ER Scoping: Open Discussion

Using the above slide as a guideline, please share your ideas on issues for the EQB Environmental Report. The ER will be a part of the PUC Hearing on the Tower Badoura HVTL Project's Biennial Projects Plan Certificate of Need application.

Re: PUC Docket No. E015/TL-05-867

Tower / Embarrass Transmission Line

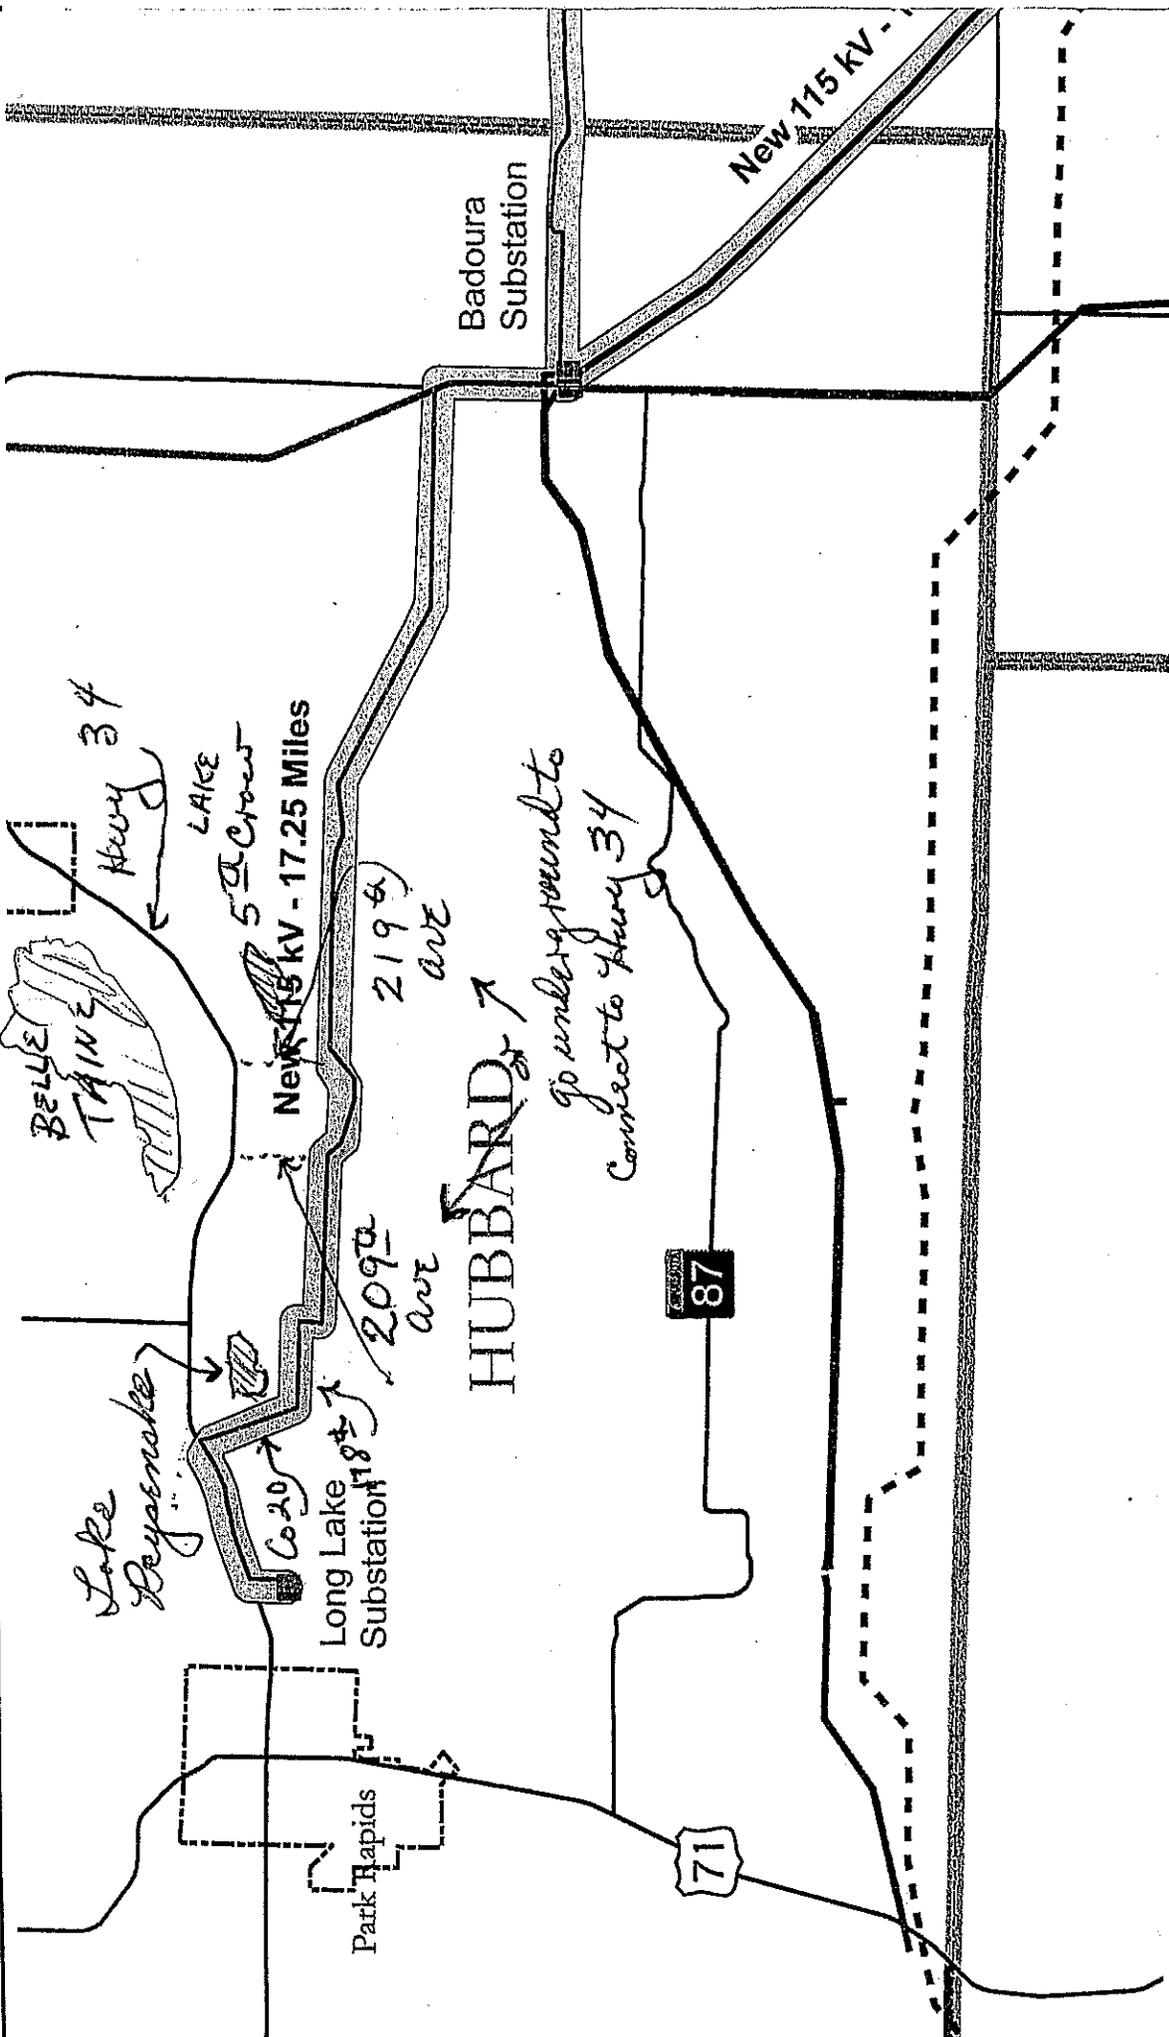
The concerns that the residents have are located near the Long Lake Substation where it goes north-south on County Rd #20 and then goes east-west on 178th Street. This is Lake Peysenske lakeshore property and will become completely residential in the near future. The proposed large poles will be placed so that they are located between the houses and the lakeshore. This is an unacceptable situation. Also, the mature trees that buffer County Road #20 and the lakeshore would probably be cut down. Furthermore, there isn't room between County #20 and the lakeshore in some places for this type of transmission line. The view to the lake would be ugly which would greatly diminish property values. There are also health and safety issues with this type of situation.

The best solution is to change the location away from the residential lakeshore of Lake Peysenske and to connect to Highway 34 by going north-south on 209th Avenue or 219th Avenue. The distance is just over 1 ½ miles in length and there is plenty of space on the Highway 34 right of way for power poles.

go underground to
connect to Hwy 34

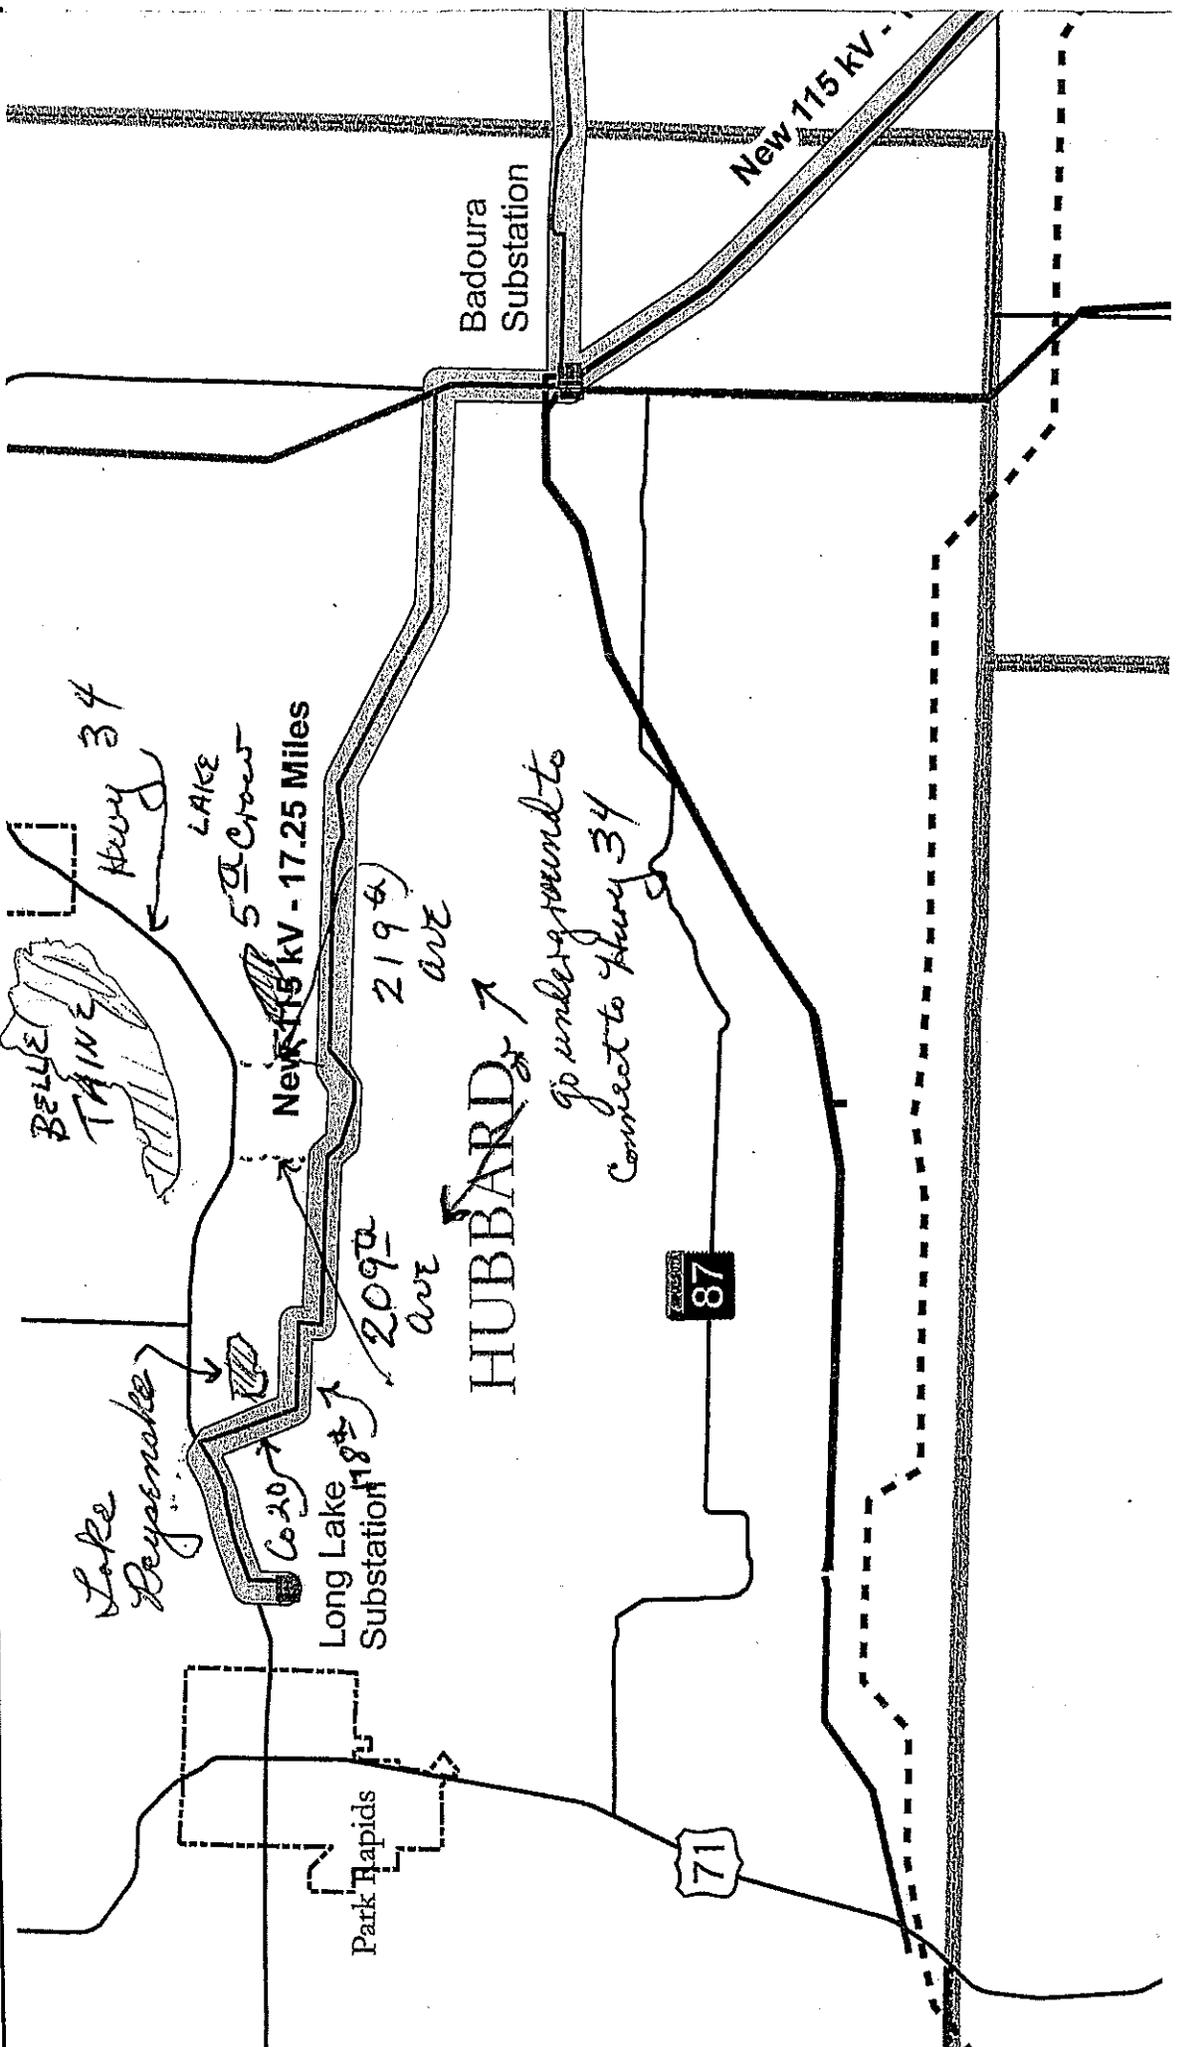
- Power line segment M, between Park Rapids and Badoura.
(Please see enclosed map)
- Existing line covers a lot of low land, rivers and lakes.
- We have extensive wild / natural life habitat. Big and small game, waterfowl, plants, and river. Low / marshlands, wild rice beds, and the state flower: lady slipper that we feel would be disturbed. Some to the point of no return.

- An upgraded line would encroach more onto our buildings, which are now about 100' from center of existing line.
After the 12/7/05 meeting at Backus, MN, we learned this section has to be completely redone to accommodate this upgrade.

- We would like to suggest rerouting the line along state hwy 34 to state hwy 64 or 34 to csa 33 to 64, using existing road right-of-ways so as to not infringe more on the various habitats by creating more right-of-way.
